Examination of Model data and reports  
on the City of Wichita, *Equus* Beds  
Aquifer and Storage Recovery Project

Case No. 18 WATER 14014

**TECHNICAL ASSESSMENT**

**ASR PERMIT MODIFICATION PROPOSAL  
REVISED MINIMUM INDEX LEVELS & AQUIFER MAINTENANCE CREDITS**

**WATER-LEVEL DRAWDOWN FROM SCENARIOS A, B and C**  
**FIGURE 6**

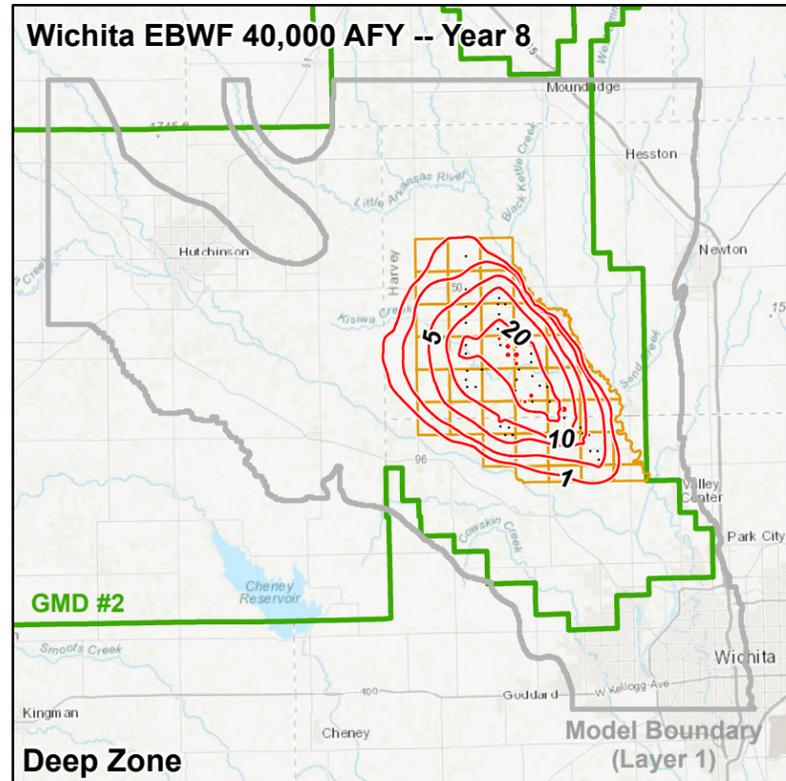
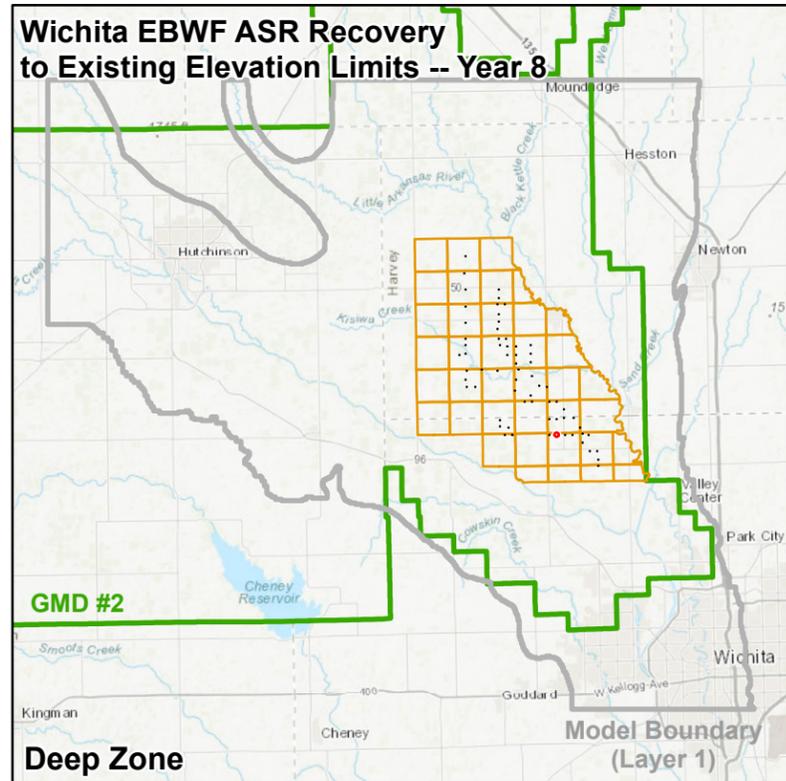
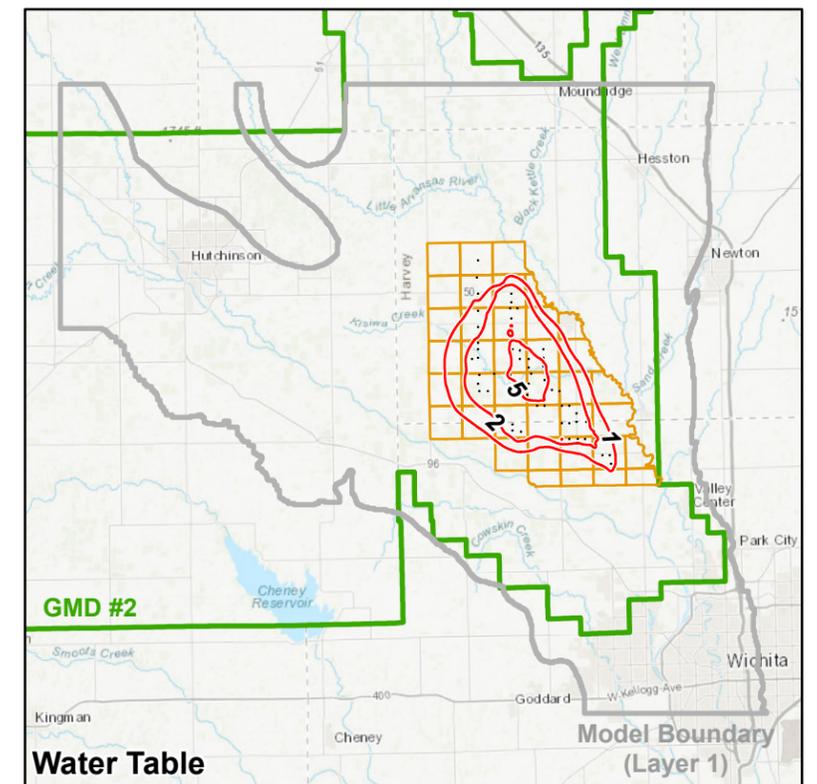
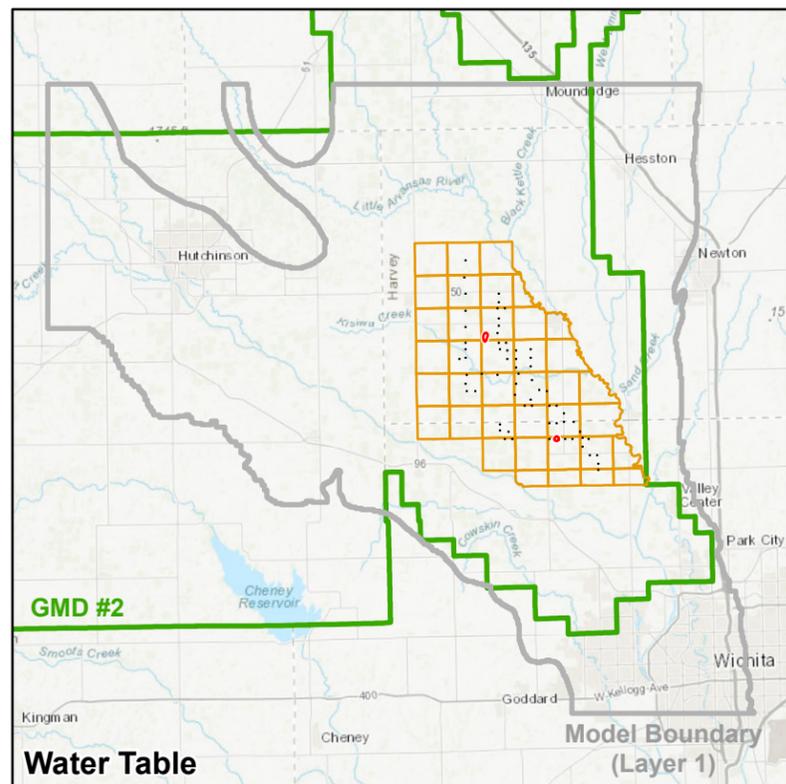
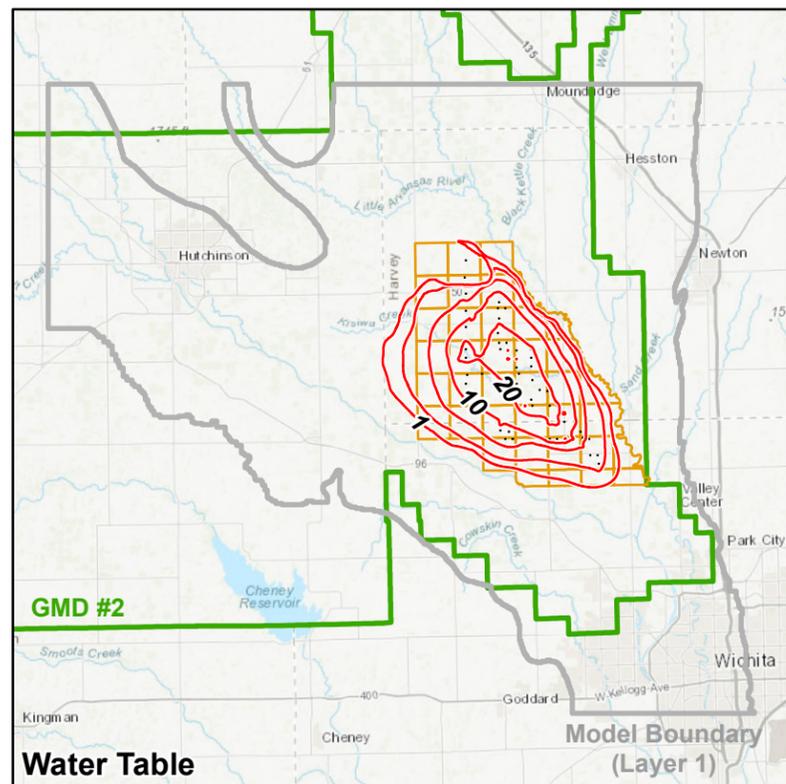
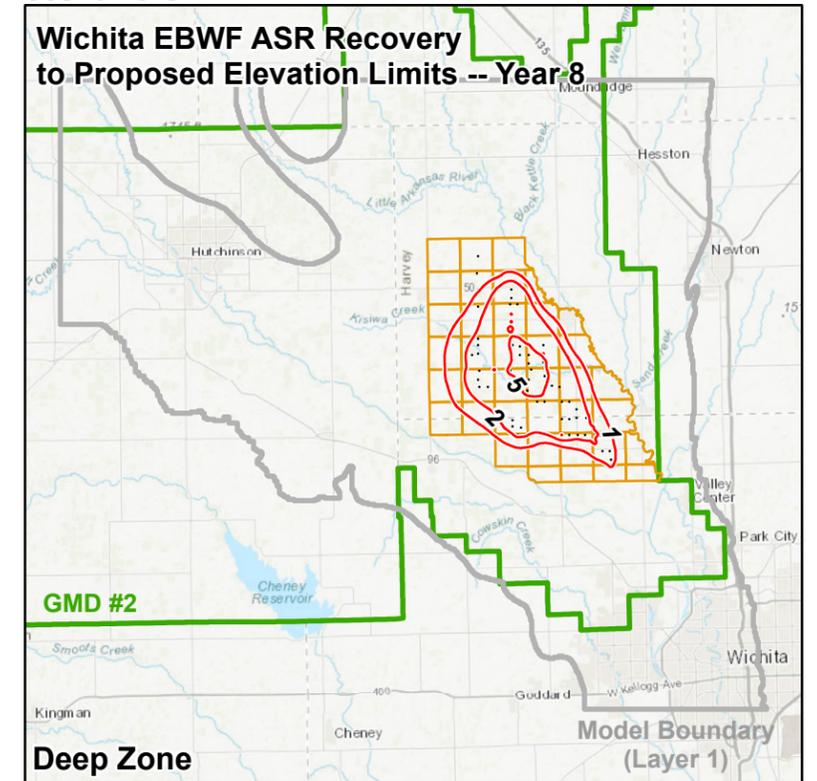
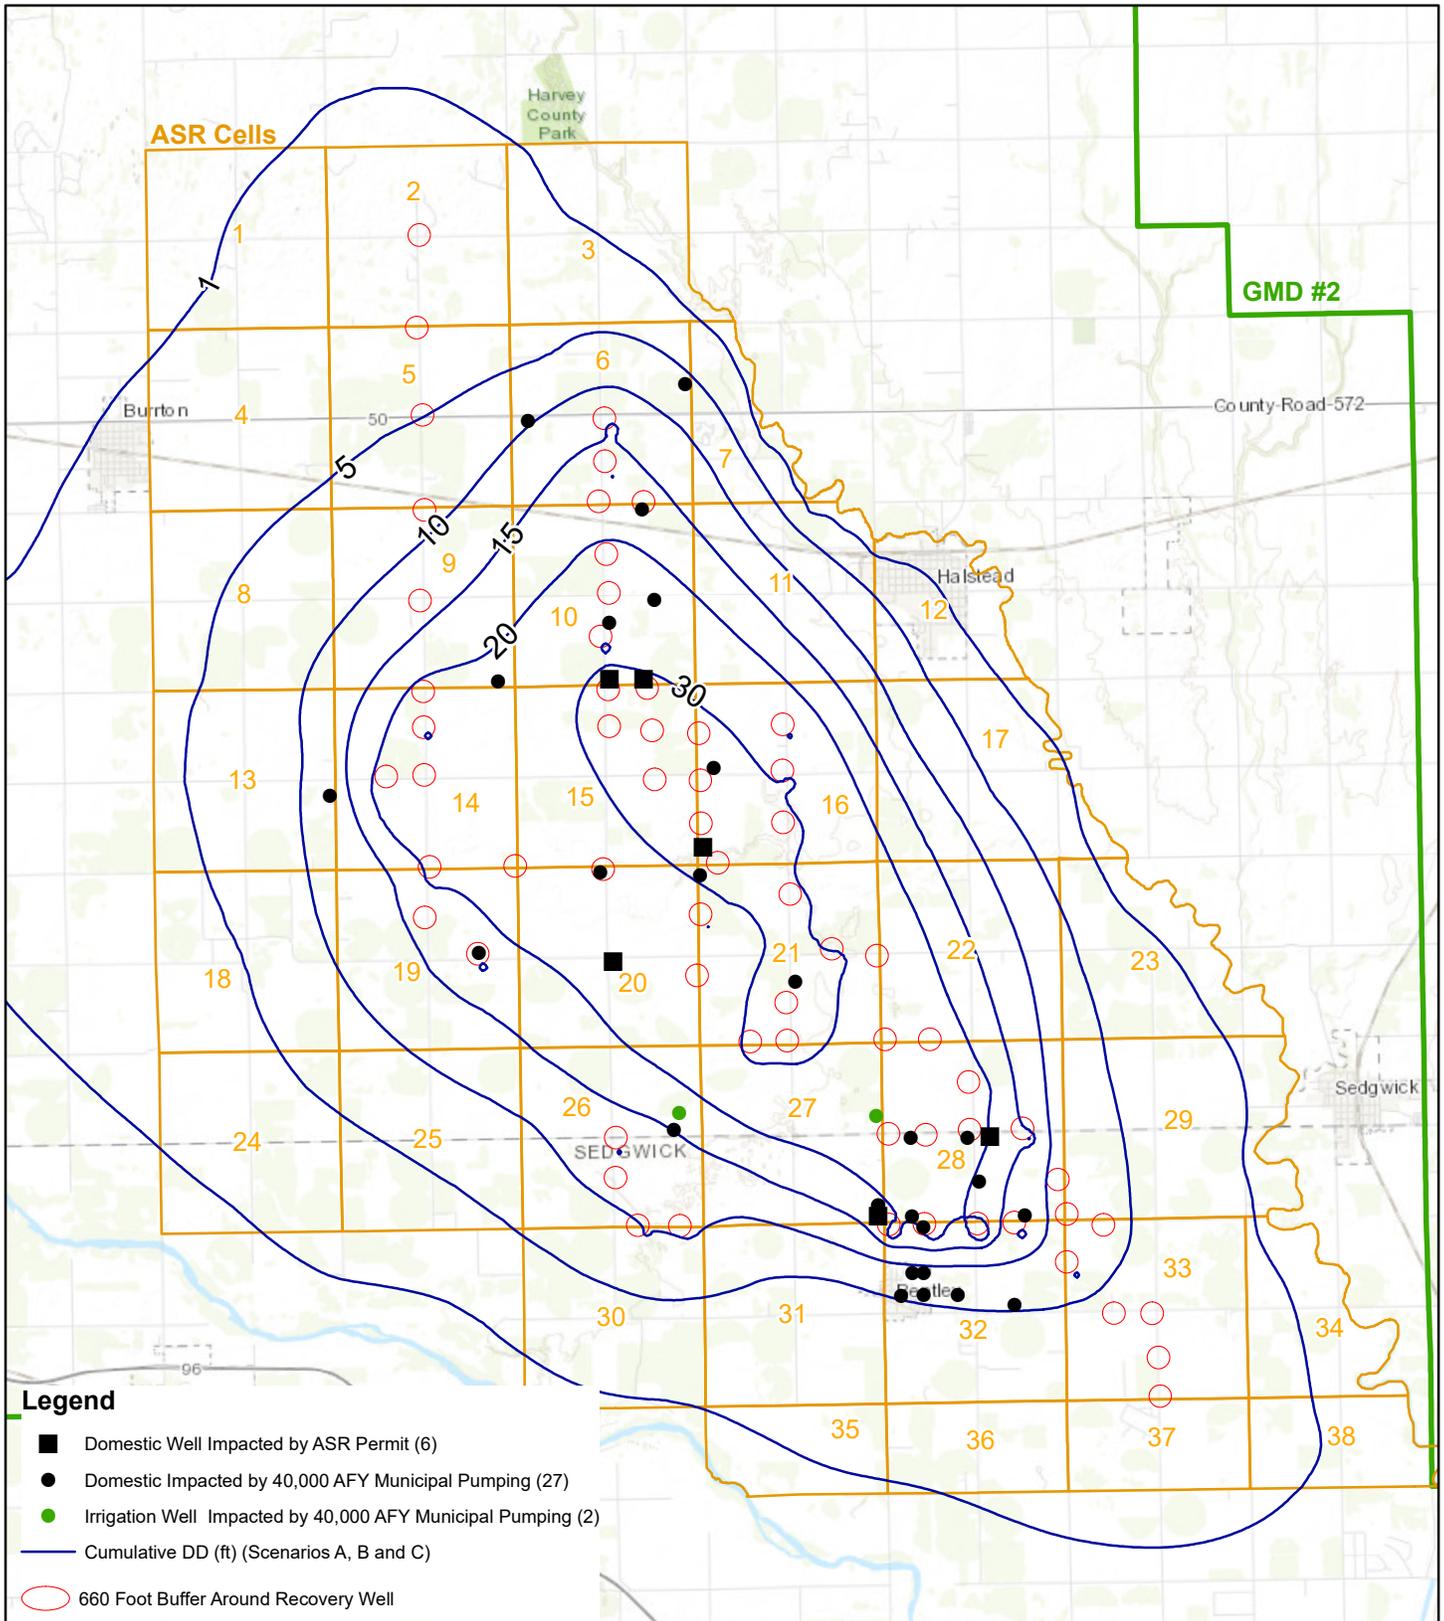
210 Scenarios A, B and C described above provide a basis for an examination of an example City  
211 pumping condition that draws down water levels to the proposed minimum index level (i.e.  
212 diverting 40,000 AF/y and ASR recharge credit water). **Figure 6** shows drawdown from each of the  
213 scenarios at the eighth year of the drought.<sup>4</sup> The drawdown illustrates an example of potential  
214 water-level impacts from City pumping if the Proposal is approved. Information on local wells can  
215 be compared to the drawdown on **Figure 6** to assess potential impacts to well water columns. The  
216 total drawdown to the proposed minimum index level is the sum of drawdown from Scenarios A, B  
217 and C.

<sup>4</sup> On Figure 6, Scenario B shows generally less than 1 foot of drawdown in most of the BSA.

**FIGURE 7**

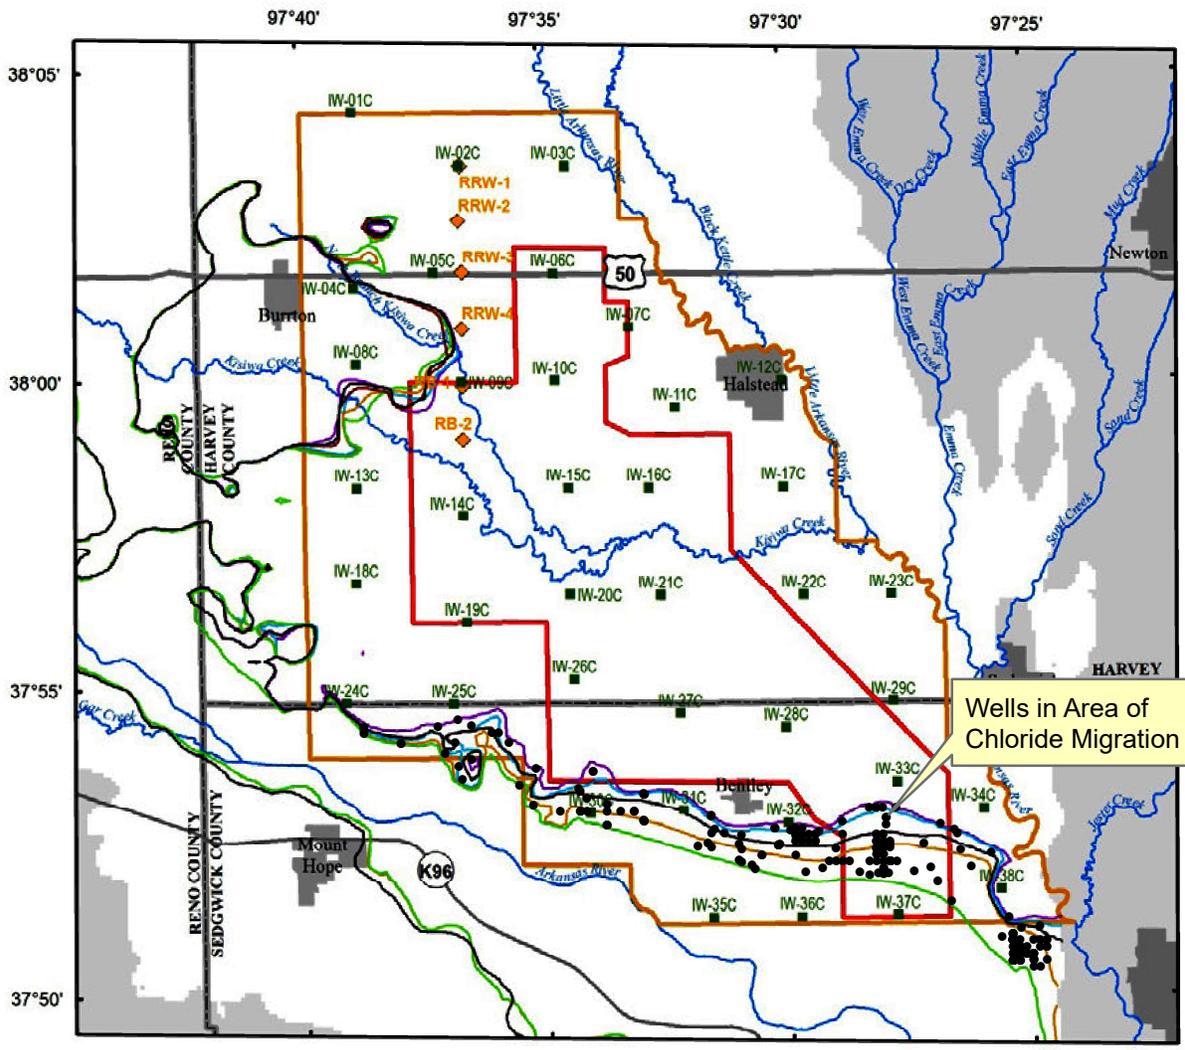
237 **Figure 7** shows the locations of City wells as red circles. The red circles represent the  
238 location of the well and a 660-foot buffer around the well location. We note that out of the wells  
239 potentially impacted, many of them are located at distances greater than 660 feet from the City  
240 wells. This indicates that the minimum well spacing regulation (K.A.R. 5-22-2) for domestic wells  
241 (660 feet), from other wells in a subject application, is not sufficient to provide protection from

242 excessive drawdown, suggesting a case-by-case assessment is needed to consider impacts from City  
243 well diversions.
